From: Hornecker, Lynn M (EFDSW)
Sent: Wednesday, August 14, 2002 8:09 AM
To: Potacka, Marianna K (EFDSW); 'bartonj@rb5s.swrcb.ca.gov';
'fdonofr@dtsc.ca.gov'
Cc: 'dchuck@mail.arc.nasa.gov'; 'msonke@envres.org'
Subject: Navy Responses to RWQCB Comments on Quarterly Basewide Groundwater
Report, Winter 2002, NASA Crows Landing Flight Facility

RESPONSE TO COMMENTS FROM THE CALIFORNIA REGIONAL WATER QUALITY CONTROL BOARD, CENTRAL VALLEY REGION
Subject: Quarterly Basewide Groundwater Report, Verification Sampling and Analysis – Winter 2002, Sixth Quarter,
NASA Crows Landing Flight Facility, Crows Landing, California (IT Corporation, June 2002)

Well 6S/8E-16M1 from the Southwest

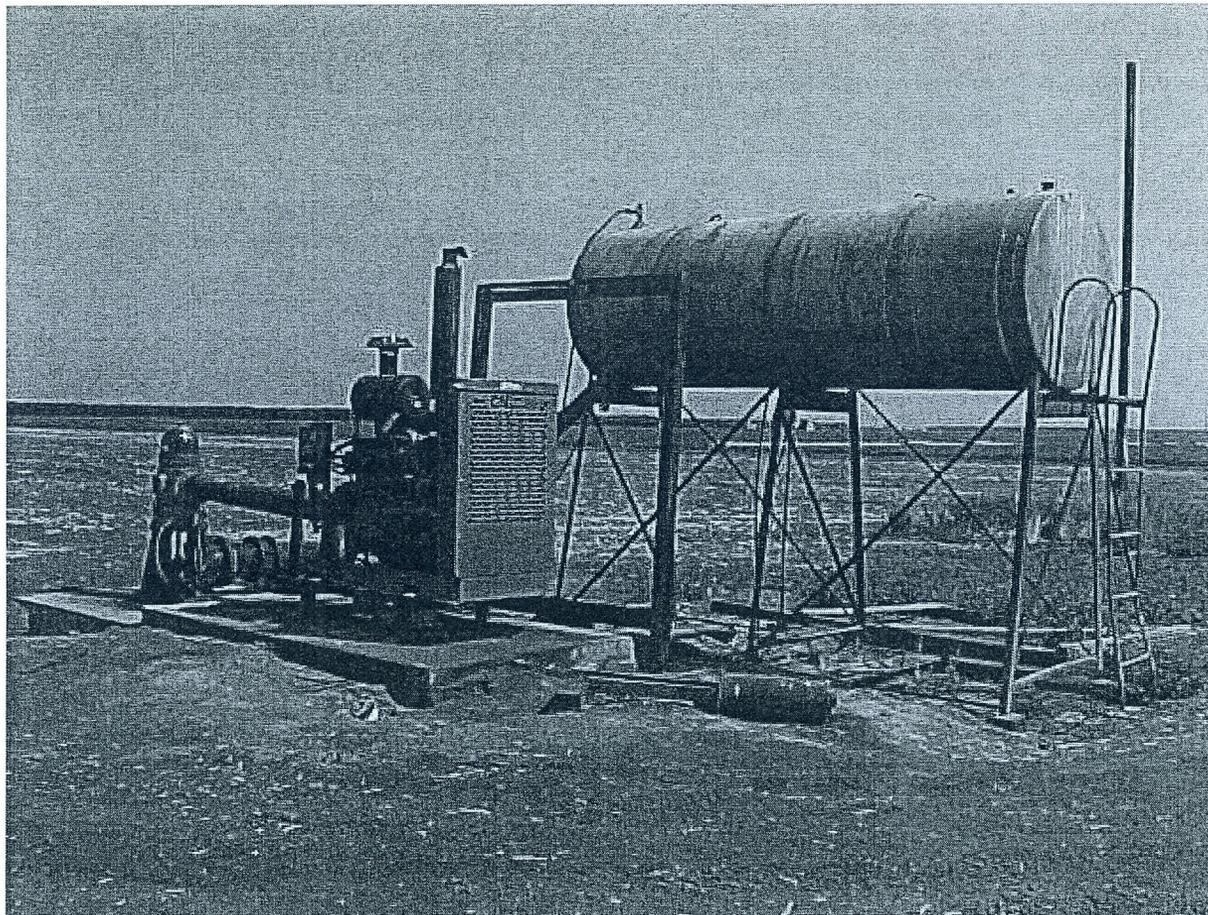
<p>2. February is typically a wet month, with no irrigation pumping from the aquifer(s). Therefore there should not be any depressions of the water table or piezometric surface that can be attributed to pumping from well 6S/8E-16M1. Additionally, other wells [17-MW-24(S) and 17-MW-24(MS)] screened in the same aquifer zones, and located at the same distance from 6S/8E-16M1, do not show similar effects. Further, a nearby automated groundwater datalogger in monitoring well 109-MW-01(S), does not show pumping effects from 6S/8E-16M1. Other factors discussed below may be causing the observed local groundwater depression in the vicinity of monitoring wells 17-MW-25(S) and 17-MW-25(MS).</p>	<p>As stated in the report, a local depression in the groundwater surface and in the mid-shallow zone is evident from the data collected on February 6, 2002. The depression was also noted in the groundwater surface in water level monitoring events conducted on August 9, 2001 (Summer 2001) and November 8, 2001 (Fall 2001). The local depression was evident from data collected in wells other than 17-MW-24(S), 17-MW-24(MS), 17-MW-25(S), and 17-MW-25(MS). The depression is potentially a result of groundwater extraction from an off-site well (6S/8E-16M1). The statement in the report does not exclude other potential causes of the localized depression, and other causes including local hydrogeological conditions are being evaluated.</p>

General Comment (continued)	Response
<p>a. Agricultural supply well 6S/8E-16M1 is listed as both active (in tabular summary) and stamped destroyed (DWR well data sheet) in the <i>Draft Findings from Record Search Activities and Visual Inspection of Active and Inactive or Destroyed Water Supply Wells, Former NALF Crows Landing</i>, dated 13 December 2001. The Department of Water resources (DWR) well data sheet may not be correct. The Navy should verify the status of well 6S/8E-16M1.</p> <p>b. In a 22 July 2002 phone conversation, the Navy stated that there is a "day tank" next to 6S/8E-16M1 well house, and that a new well may have been drilled at that location. The Navy should verify whether a new well has been installed at that location.</p> <p>c. The groundwater depression may not be the result of a local effect around monitoring wells 17-MW-25(S) and 17-MW-25(MS), but a trend in the hydrogeology. An incorrect water level (see specific comment 3) was used to generate Figure 3 (Potentiometric Surface Map). Correcting the error creates a sharper "S" curve in the potentiometric surface contour line representing 84 feet of elevation, which better correlates to the "S" curves in upgradient MS zone potentiometric surface contour lines (85 feet and 86 feet).</p> <p>d. An error of one foot (too low) in the top of casing elevation for monitoring wells 17-MW-25(S) and 17-MW-25(MS) might account for the observed local groundwater depression. The Navy should verify the top of casing elevations for the following monitoring wells: 17-MW-24(S), 17-MW-24(MS), 17-MW-25(S), 17-MW-25(MS), and 109-MW-01(S).</p> <p>The Navy needs to evaluate all possible causes for the groundwater depression prior to conducting an off-site investigation.</p>	<p>a. The Navy has verified that a well does exist at the location of 6S/8E-16M1 (see attached photo). A pump with motor and diesel day tank is installed at the well and is believed to be operational. The operating time and capacity of the pump has not been confirmed with the property/well owner.</p> <p>b. The accuracy of the DWR well data sheet (stamped destroyed) and the possibility that a new well was installed at the location cannot be confirmed from the county records. There are no county records that indicate that a new well was installed at the location. It is likely that the original well was never destroyed and the stamp on the DWR well data sheet is inaccurate.</p> <p>c. It is possible that the local depression is a trend in hydrogeology and is not due to pumping from 6S/8E-16M1, or is enhanced by pumping from 6S/8E-16M1. The trend was first noted in the summer of 2001 (before 17-MW-25(S) was installed) and pumping from the agricultural well was believed to be the most likely cause. Additional data from the fall 2001 and winter 2002 (after 17-MW-25(S) was installed as an additional data point) indicate that the depression is still evident, even when agricultural pumping is minimal. This indicates that the gradient may be a hydrogeologic trend. As stated in the report, additional data is required to confirm the cause of the depression and evaluate the long-term groundwater gradient. Cross sections are being developed from recent soil borings and well installation activities to evaluate subsurface geology/hydrogeology.</p> <p>d. The elevations of the top of casing for all wells in the area were confirmed when the local depression was first noted. The elevations of wells used to evaluate water table elevation and potentiometric surface elevation in the mid-shallow zone are accurate.</p> <p>No off-site investigation is currently planned. The Navy will continue to collect water level and chemical data from wells along Bell Road to evaluate the groundwater gradient and potential factors that influence the gradient and to develop and refine a conceptual model of the Administration Area Plume.</p>

FIGURE 3

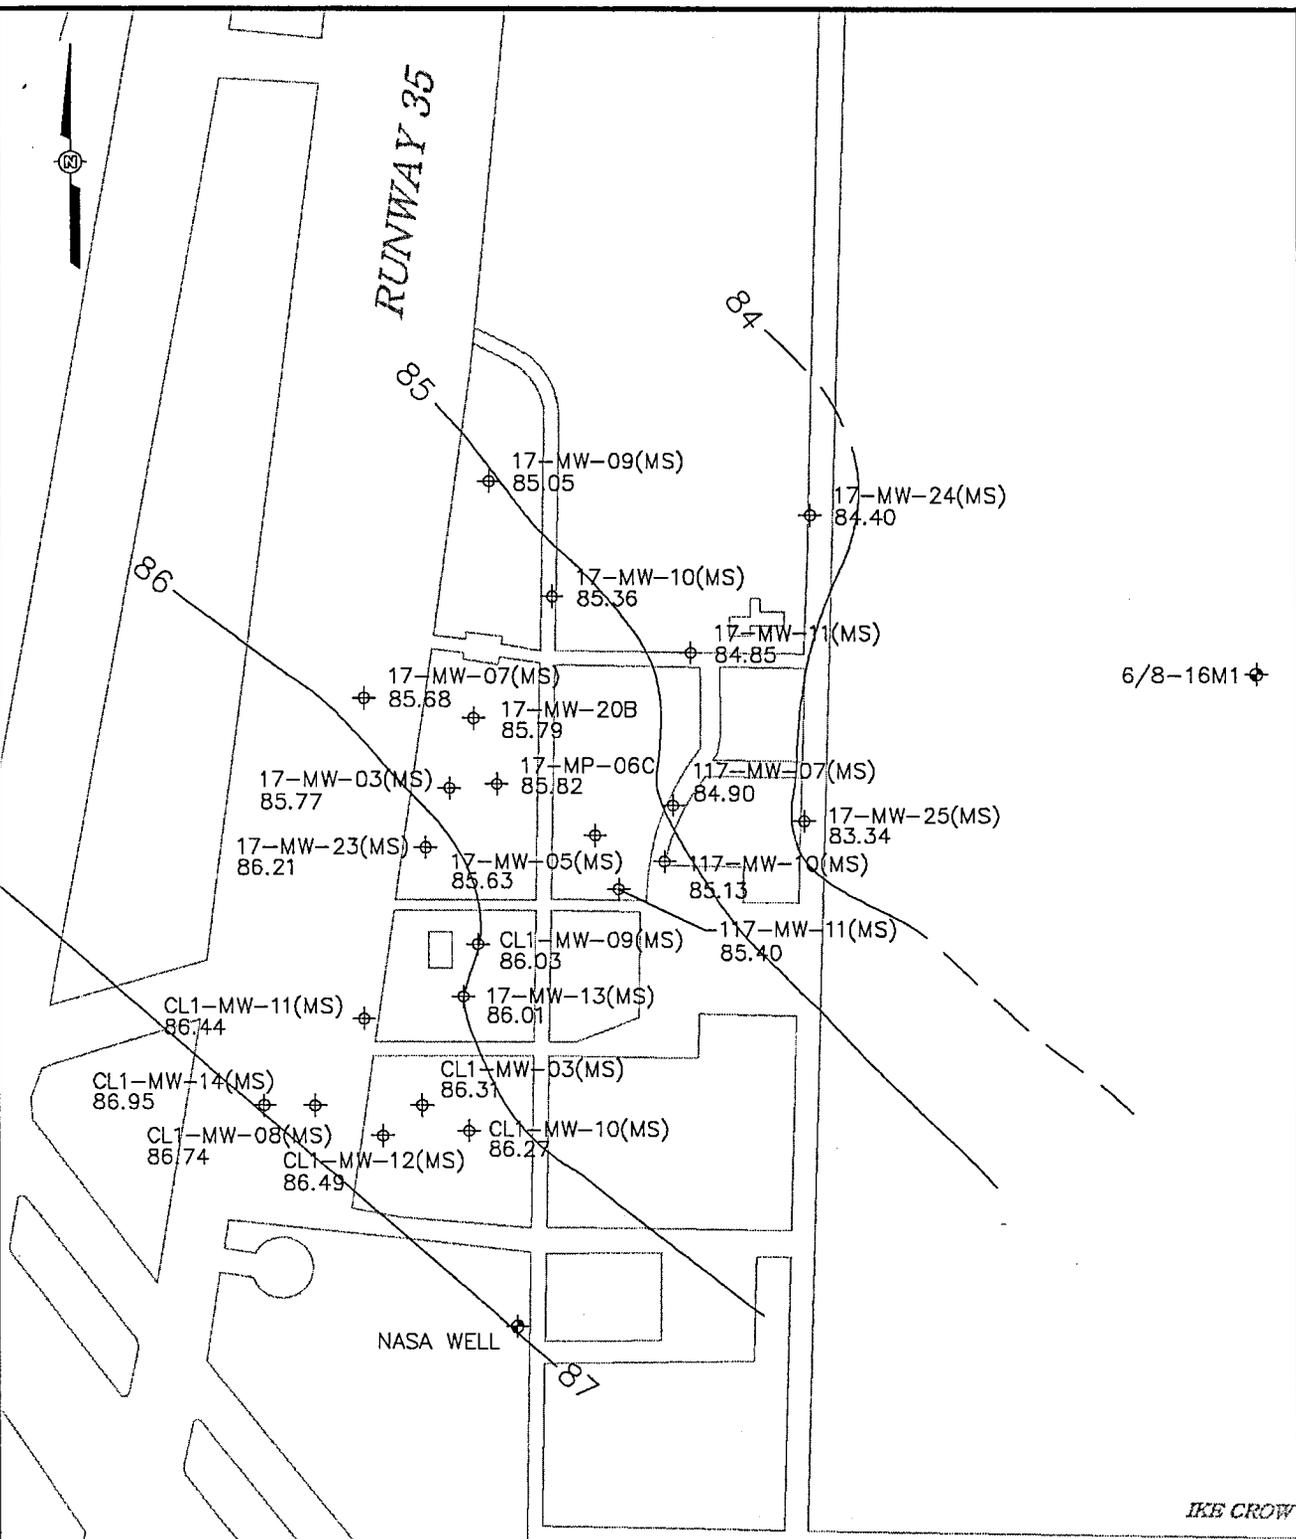
<p>2. Section 3.2 Groundwater Analytical Results: The text states that general chemistry results presented in the Report will be interpreted in another report. Please provide the name and proposed release date for the other report, so that we may schedule our review.</p>	<p>An evaluation of the natural attenuation of chlorinated solvents and petroleum hydrocarbons is being completed using the chemical and geochemical results from previous groundwater monitoring events. The results of the evaluation will be included in a natural attenuation report. The details of the report title, specific content, and distribution date have not been determined. A draft of the report will likely be available for review within the next few months.</p>
<p>3. Figure 3: The potentiometric surface (MS groundwater elevation) value shown for 17-MW-24(MS) (83.34) is incorrect. The correct value for 17-MW-24(MS) from Table 1 is 84.40 feet above mean sea level. Please correct the figure, and issue a replacement page for the Report with the next quarterly report.</p>	<p>The attached replacement figure includes the corrected potentiometric surface elevation for well 17-MW-24(MS). This corrected figure will also be included in the Annual Report.</p>
